INITIAL FIRE SAFETY INSPECTION REPORT

Ananta Huaxiang Ltd. (Extension 2)

RSC ID: 26399

Date: 13-October-2025

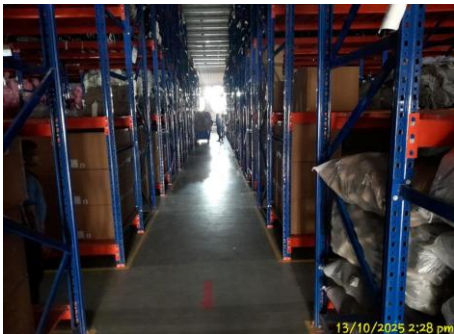
F-02	Means of Egress	During the inspection, it was observed that Vision glass was broken, smoke seal was missing/damaged, and some of the installed fire doors were missing listing labels/ not clearly visible for fire door frame & leaf. Listing labels were missing on some fire door accessories (such as exit hardware, door closers). Technical datasheet & certificate are missing for all fire door accessories. In addition, field modification (Changes made to a listed assembly or component after it has been manufactured) has been observed. Location(s): All floors (Building-D & E).	Replace/install the non-functional/missing fire door accessories and properly inspect, test & maintain fire door as per NFPA 80. In cases of a field modification, the laboratory with which the product or component being modified is listed shall be contacted through the manufacturer and a written or graphic description of the modifications shall be presented to that laboratory. A written authorization from that laboratory is required. Field modification shall conduct as per NFPA 80. Keep proper datasheet & certifications for installed fire doors & accessories on-site for verification.	Within 3 Months

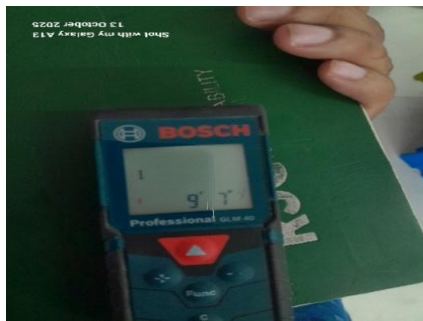
F-10	Means of Egress	Minimum ceiling height of the production floor is less than 3.3 meters for New Building. Location(s): Ground & 1st Floors, Building-D; Available Height: 3.16 m. All floors except GF, Building-E; Available Height: 2.9 m.	The ceiling height of a production floor shall not be less than 3.3 meter as per article 1.2, chapter 1, part III and article 2.11, Part III, Chapter -2, BNBC 2020.	Within 3 Months
------	-----------------	--	---	-----------------

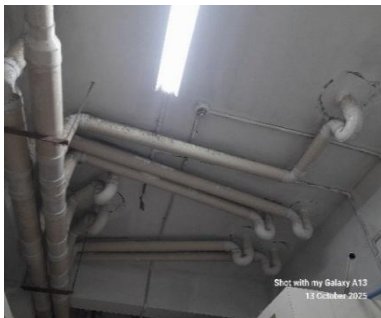
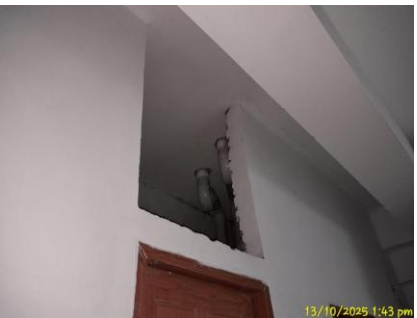
F-11	Fire Rated Construction	Areas used for in-process storage of combustible materials are open to the surrounding production occupancy. Location: GF & 1st Floors (Building-D); GF, 1st Floors, 3rd & 5th floors (Building-E).	Provide defined storage areas and limit the storage arrangement as follows: Maximum height of 2.45 m and maximum area of 23 m² and is separated by a minimum 3.0 m (10ft) from other storage areas and they do not exceed 10 percent of the building area of the story in which they occur. or, If sprinkler protected, Maximum height 12 ft (3.66 m) and maximum area of 1000 ft² (93 m²) and separated by a at least 25 ft (7.62 m) and does not constitute more than 10 percent of the building area or 4000 ft² (372 m²) of the sprinklered area, whichever is greater. or, Enclose the storage area from the surrounding occupancy with a minimum 1 hour construction.	Within 3 Months
